HISTORIC PRESERVATION REVIEW BOARD STAFF REPORT AND RECOMMENDATION

Landmark/District:	Mount Vernon Triangle Historic District	<input checked="" type="checkbox"/> Agenda
Address:	444-446 K Street NW	<input type="checkbox"/> Consent
		<input checked="" type="checkbox"/> Concept
Meeting Date:	September 27, 2018	<input checked="" type="checkbox"/> Alteration
Case Number:	18-616	<input checked="" type="checkbox"/> New Construction
		<input type="checkbox"/> Demolition
		<input type="checkbox"/> Subdivision

Studio Crowley Hall, architects and agent for property owner Han Jan, seeks conceptual design review of a six-story addition at the rear of two two-story rowhouses built in the late 1800s.

September 2016 – Proposed 1st Floor

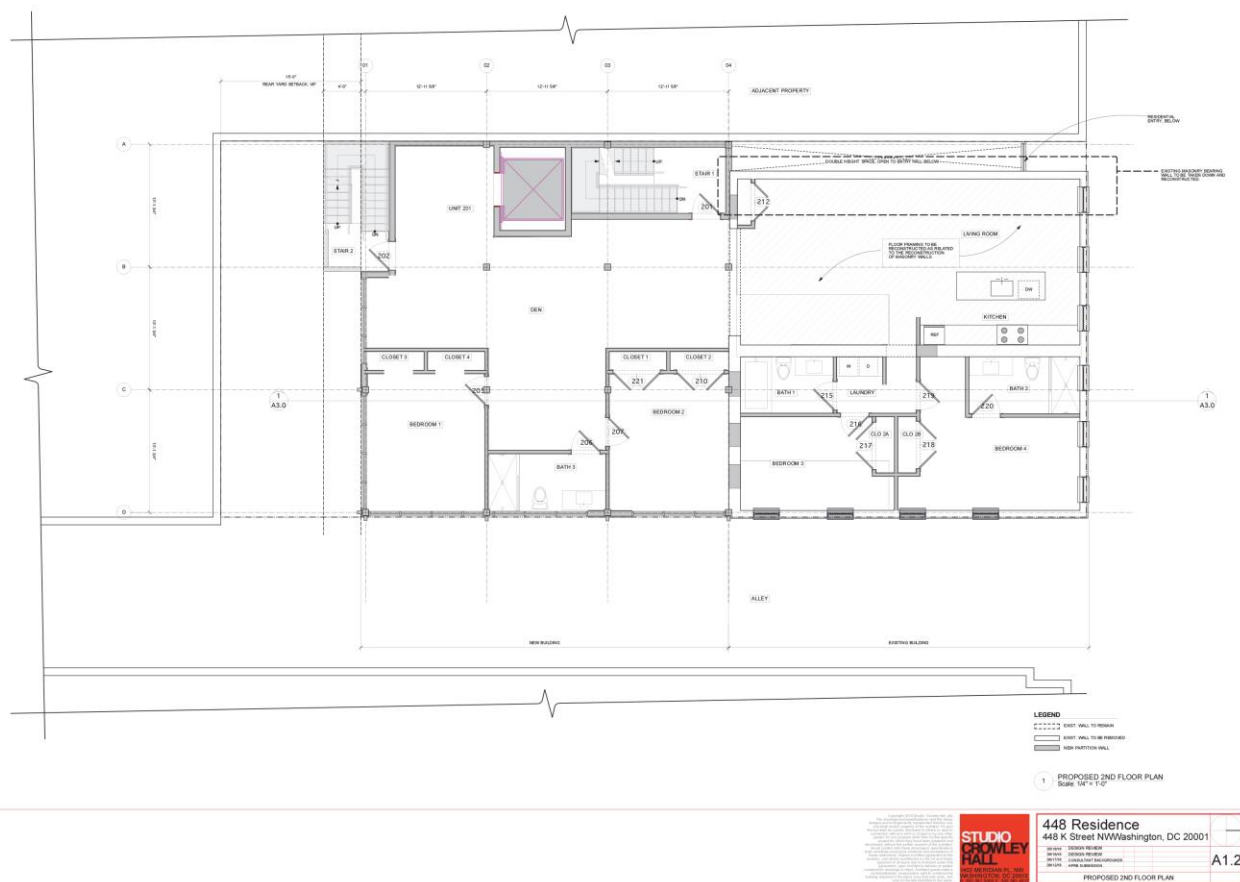
The project design before the Board today is similar but is now a six-story addition at the rear of the historic buildings with a revised interior plan on all levels. The architectural metal louver screen design would wrap the front and side elevations, similar to the previous submission. The first floor will be retail with a ground floor entrance at 444 K, and the entrance to the residential area will be located in a slot between 446 and 450 K Street – however, it is unclear if this space is wide enough to meet code requirements.
